**THE PORT DISTRICT OF SOUTH WHIDBEY ISLAND
SPECIAL MEETING**

RE: POSW Fairgrounds Food Pavilion
Structural Repair Work Description Addendum

PROJECT: Food Booth Foundation Repair 2024-02

RE: POSW Fairgrounds Food Pavilion
Special Inspection & New Bearing and Shear Walls

DATE:
05/31/2024
PLAN NUMBER:
1/SSK
SCALE
3/4" = 1'-0"

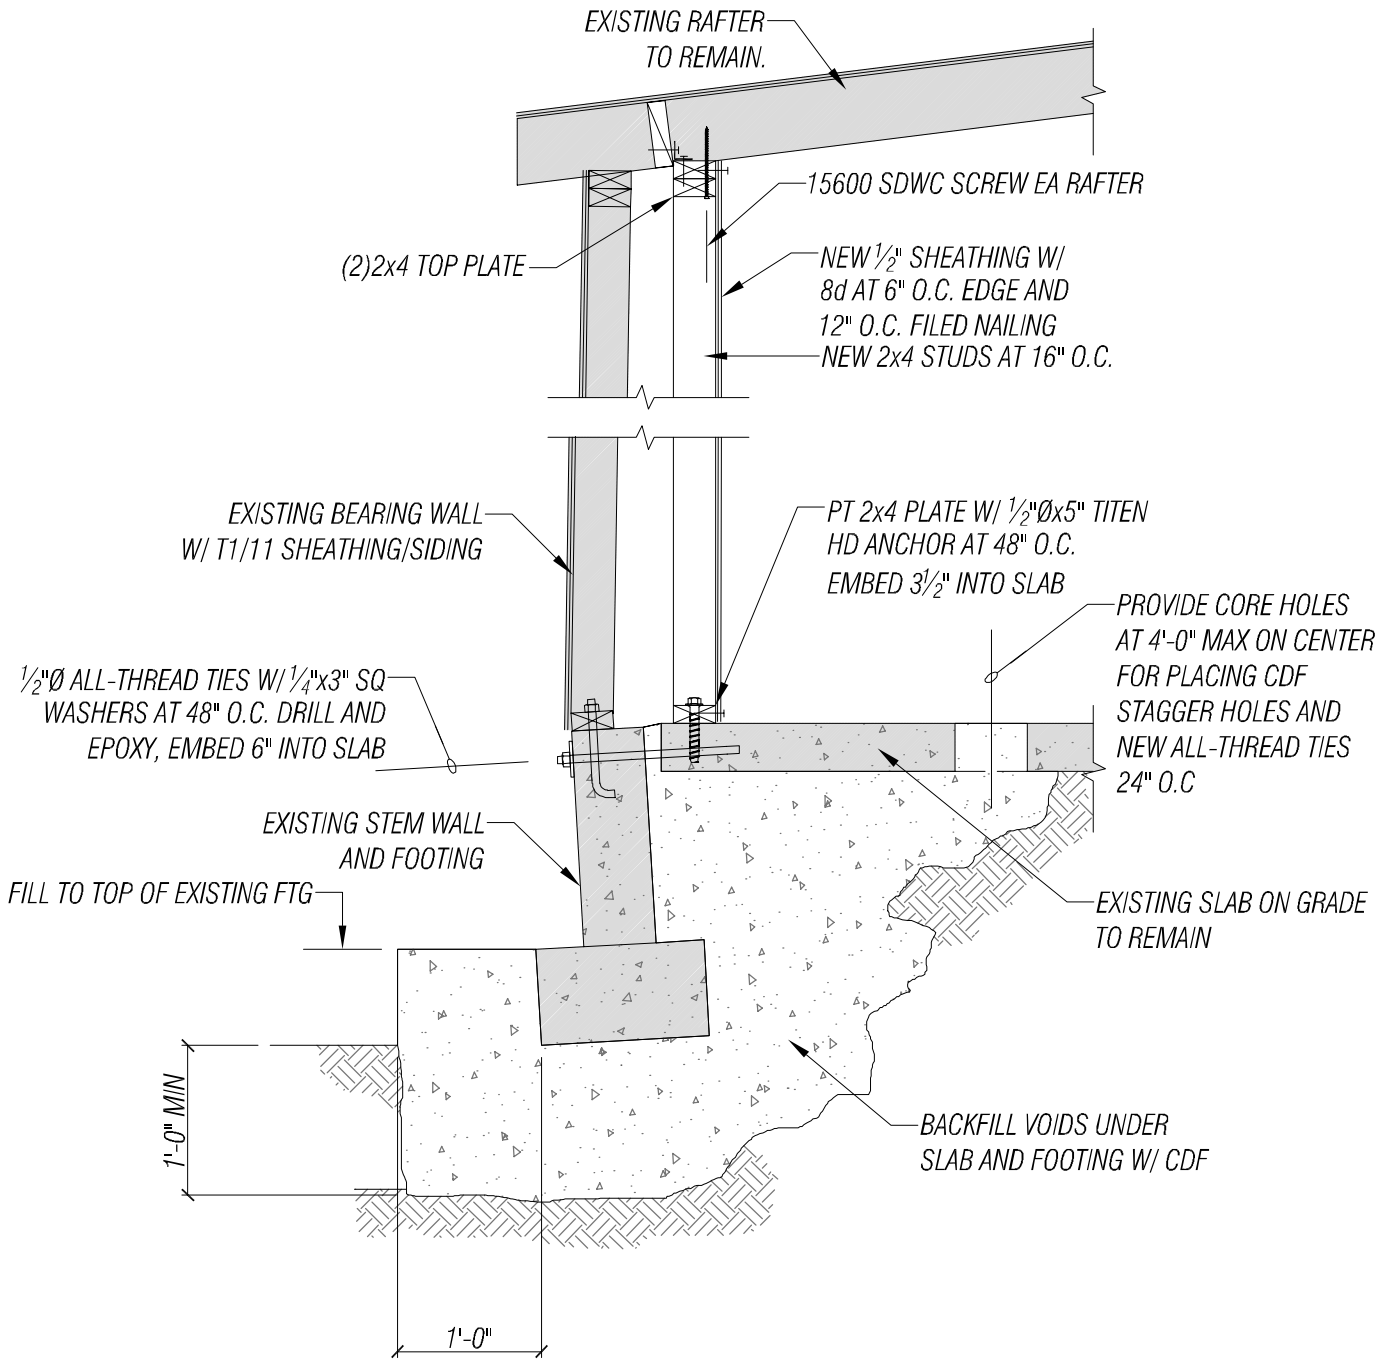
During the meeting on May 30, 2024, a proposed repair option for the foundation on the north side of the building was reviewed. This option, as stated in a DCG/Watershed memo dated December 12, 2023, suggests that the stem wall and footing should be replaced. Alternatively, the stem wall can remain in place, provided a new bearing wall is supported on the existing slab once control density fill (CDF) is placed to fill the voids under the slab and existing footing. Please refer to the SSK attached for more details.

Figure 2 – Shearwall Framing Detail

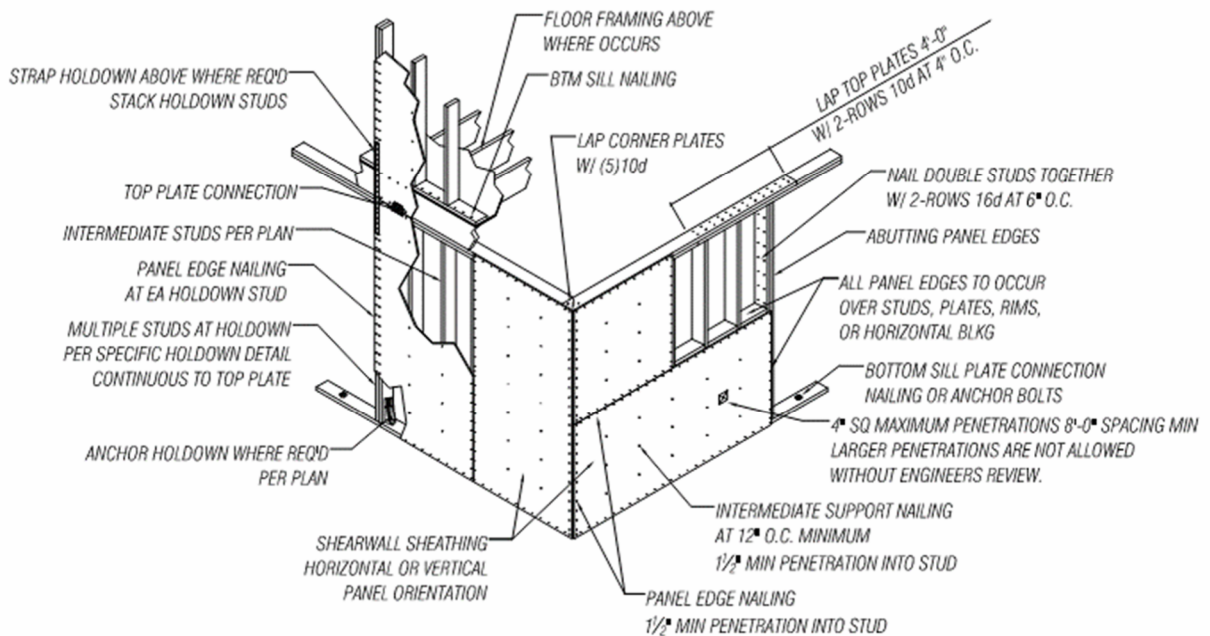
Shear walls require a minimum of 10 shear panels that are 32" long or 7 shear panels that are 48" long and are full wall height with 2x4 studs at 16" o.c. Provide at least one panel in each booth. Base and top plate connections shall be as specified in the 1/SSK provided in the May 31, 2024 memo. These piers can be located at the owner/contractor's discretion, such that they can avoid the location of existing openings, electrical outlets, and plumbing equipment. These piers should generally be provided at 16'-0" on center max. Holdowns are not required. Refer to Figure 2 for additional requirements for shear wall construction. Calculations are attached.
